WEINBERGER SUBDIVISION FINAL ENVIRONMENTAL IMPACT STATEMENT

Proposed Action: 48 Lot Single Family Residential Subdivision

Grandview Avenue and South Parker Drive
VILLAGE OF MONTEBELLO, TOWN OF RAMAPO, ROCKLAND COUNTY, NEW
YORK

November 14, 2006

Figure 3.5-1: Sample Lots Tree Preservation (Standard Plan)*
 Weinberger Subdivision FEIS
 Village of Montebello, Rockland County, New York
 Source: Leonard Jackson Associates, 09/05/2006
 * Also potentially applicable to Cluster Plan

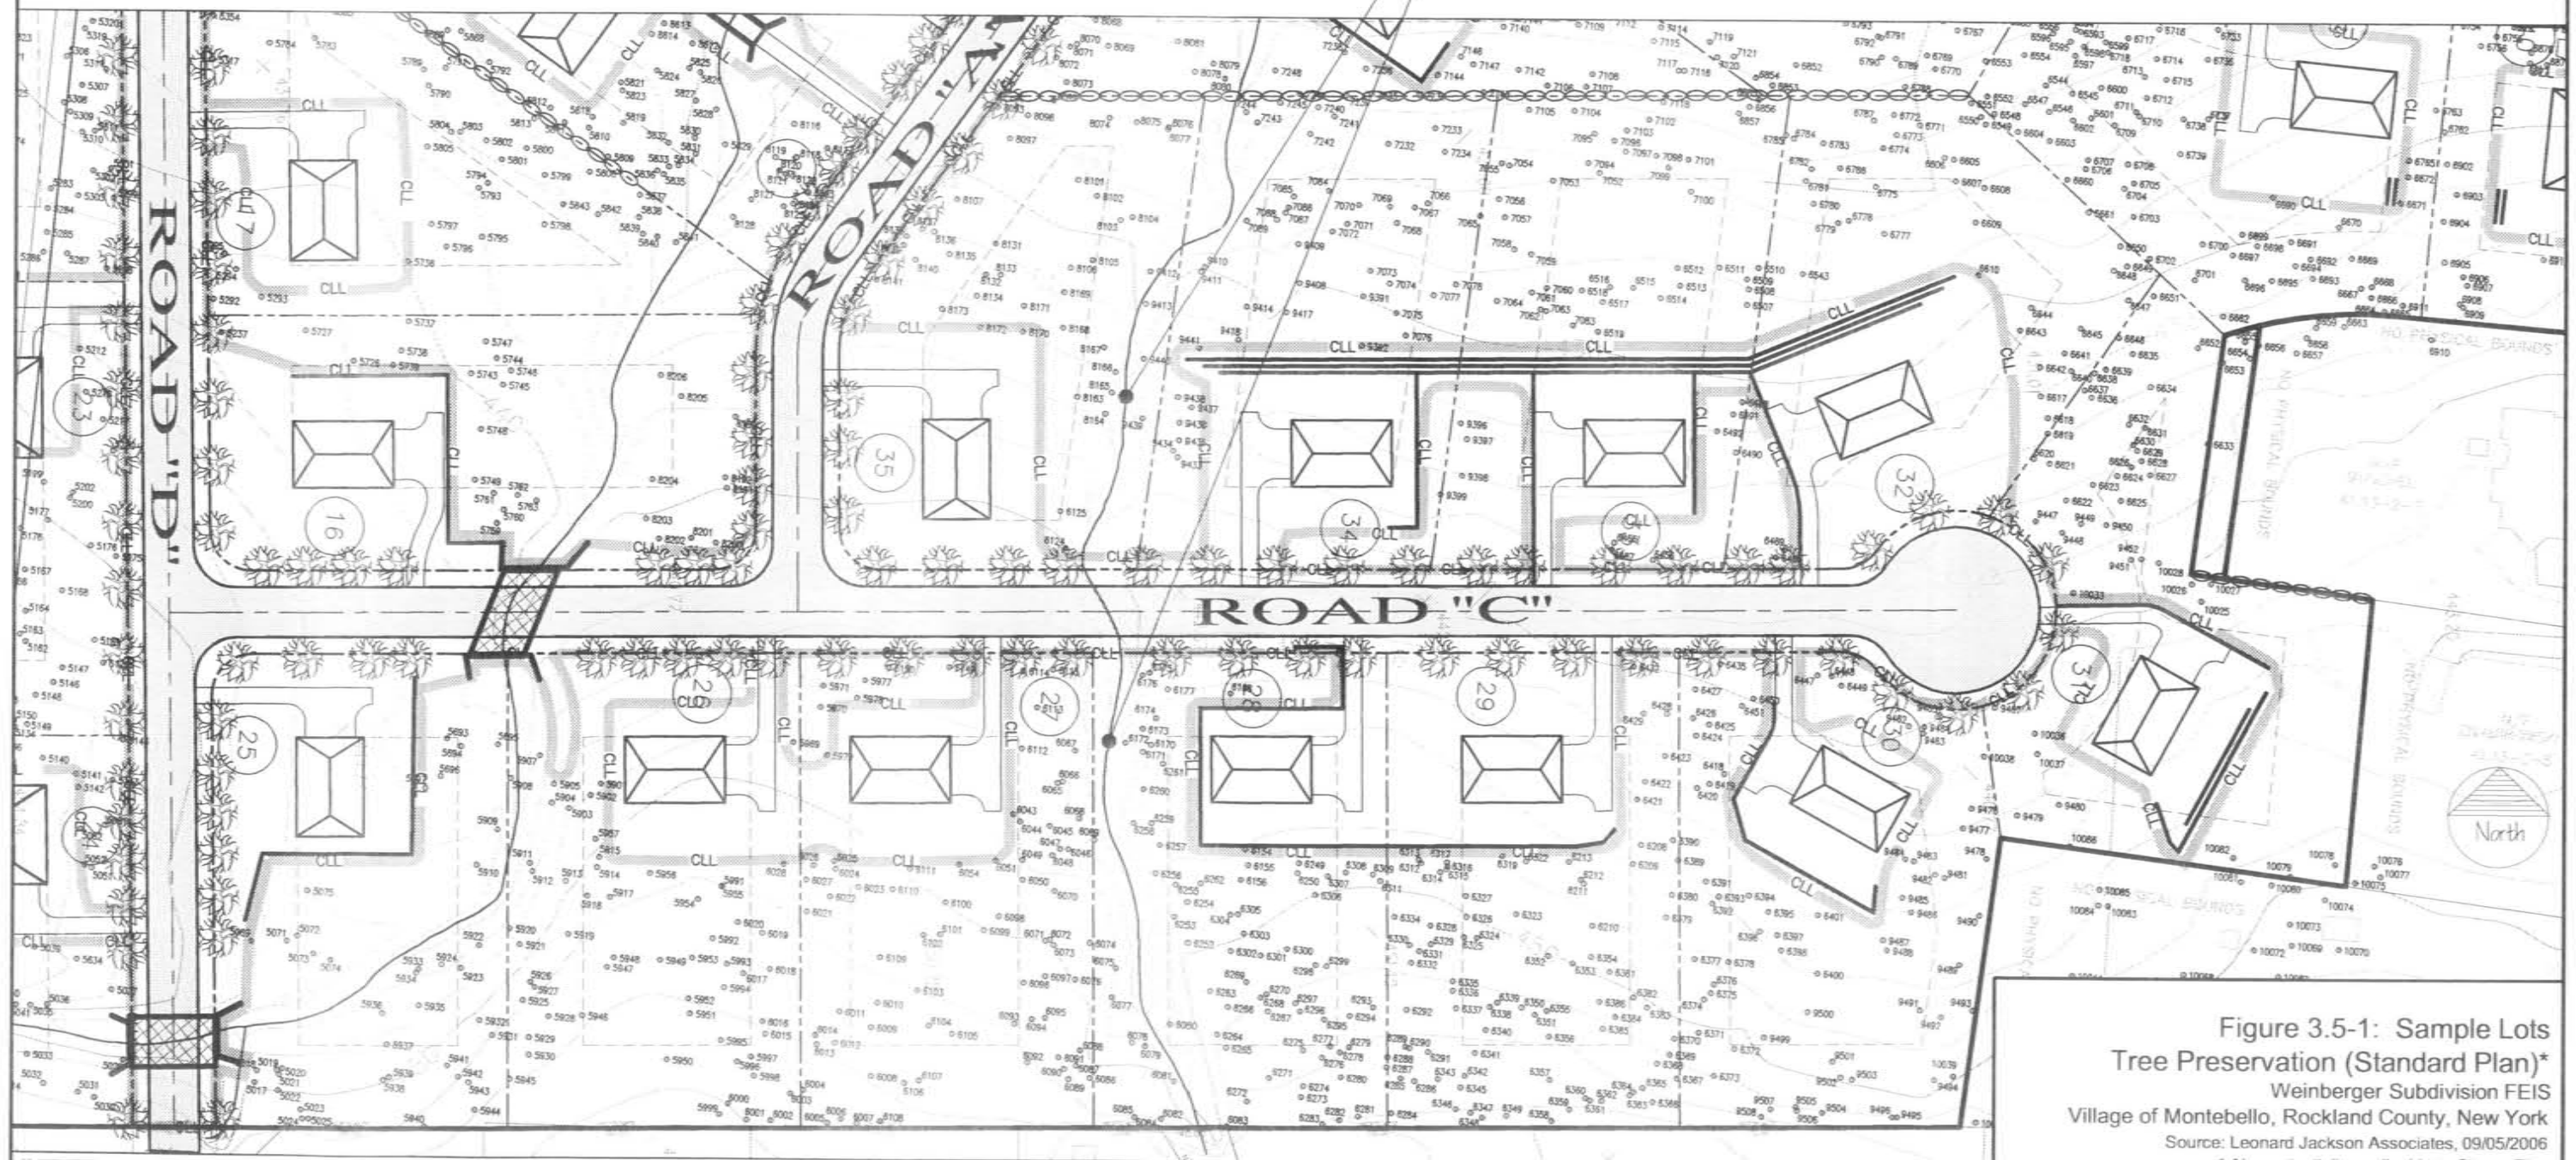
The applicant requests on page 3.5-1 that the Village approve tree clearing of any tree not outside the limits of clearing. However, the limits of clearing are not realistic. Hardly any usable yard area has been provided for the new residences. Access to some lots are shown on the maps as being no wider than ten feet, a dubious width to provide access to bulldozers, dump trucks, backhoes, etc. Further, the clearing limits shown in the DEIS at figures 3.5-2 and 3.5-3 are not consistent with those shown in the full-sized plan set at 4A and 4B. The tree map provided is not adequate in that it does not provide a reference of where trees are located in relation to limits of clearing or other subdivision plan features. Approval of a tree clearing plan based on currently submitted materials would not be protective of the environment, and would likely require the project sponsor to make supplemental applications in the future once a more realistic grading plan that provides yards for residents is developed.

Plans submitted with the DEIS include the proposed plans with an overlay of the tree survey. The following Figure 3.5-1 shows typical lots with refined limits of disturbance and indication of trees proposed for removal. The limits of disturbance, as indicated for these typical lots, are considered to be reasonable and appropriate and allow for sufficient yard area and preservation, where feasible, of trees near the road. The detailed extent of clearing for the entire project will be determined during final site plan review. Figure 3.5-2 shows a single typical lot and dimensions the typical clearing limit line.
